Schindler Elevator Corporation

Re: Introduction of Destination-Oriented Elevators Into New California Building Code

PARTICIPATION COMMENTS FOR THE NOTICE DATED AUGUST 22, 2006
Written comments are to be sent to the above address.

Destination Oriented passenger elevators - Figure __

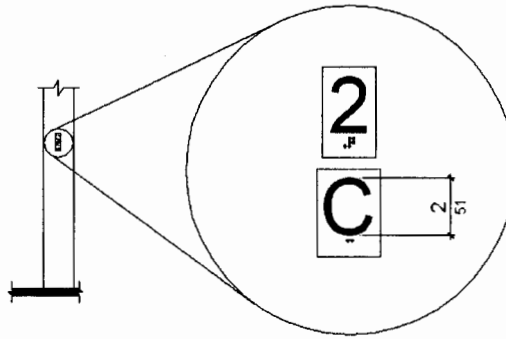
Add new figure to support the amended text on associated 1116B.1.14 comment:

The figure shown is the same as has been in ICC/ANSI A117.1-1998 third printing and the same as Fig. 407.2.3.2 now in ICC/ANSI A117.1-2003. A117.1 is a reference document in the IBC. *Note: should be 3 Braille dots in line below the C*
Insertion in Title 24 will assure national consistency.

Destination Oriented passenger elevators shall additionally provide car identification in raised characters complying with that are a minimum of 2 inches (51mm) in height and conform to Section 1117B.5.5 and Grade 2 Braille that conforms to Section 1117B.5.6 immediately below the floor designation on both jambs.

The raised characters shall other wise comply with Sections 1117B5.3, 1117B.5.4 and 117B.5.2. See Figure 44B-40B-11B-40C. Permanently applied plates are acceptable if they are permanently fixed to the jambs.
